TO:
 ATTN:
 SUBJECT: Inadequate MRB Scraper Spring Tension

FIX ON FAILURE (Failure Code 20.19)
 Effective serial number range: Model year 2018 MRB3's

Scraper tension spring

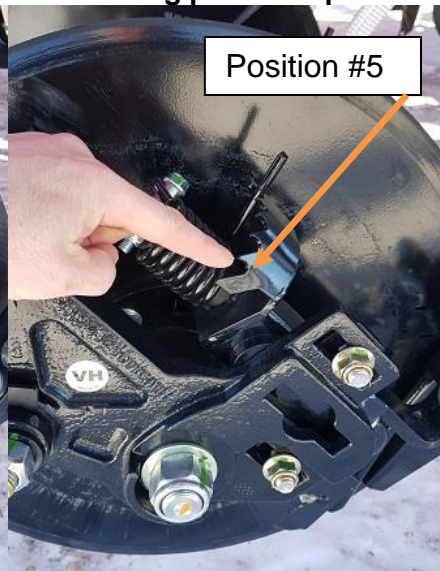
1. Using the scraper tension adjustment tool adjust the scraper tension from position #1 to position #5 and back again – repeat two to three times – faulty springs will “lose” tension when placed back in position #1 after being placed in position #5

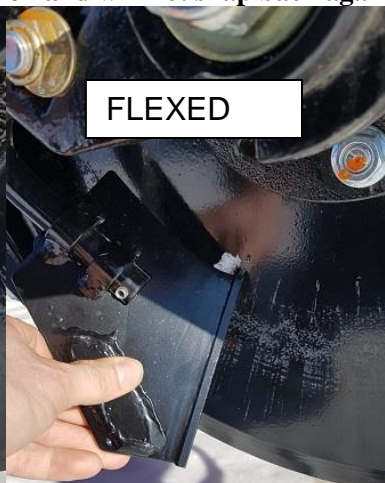
2. “FLEX” the scraper from the home position to a position away from the coulter – repeat two to three times – faulty springs will “lose” tension and will not snap back against the coulter.
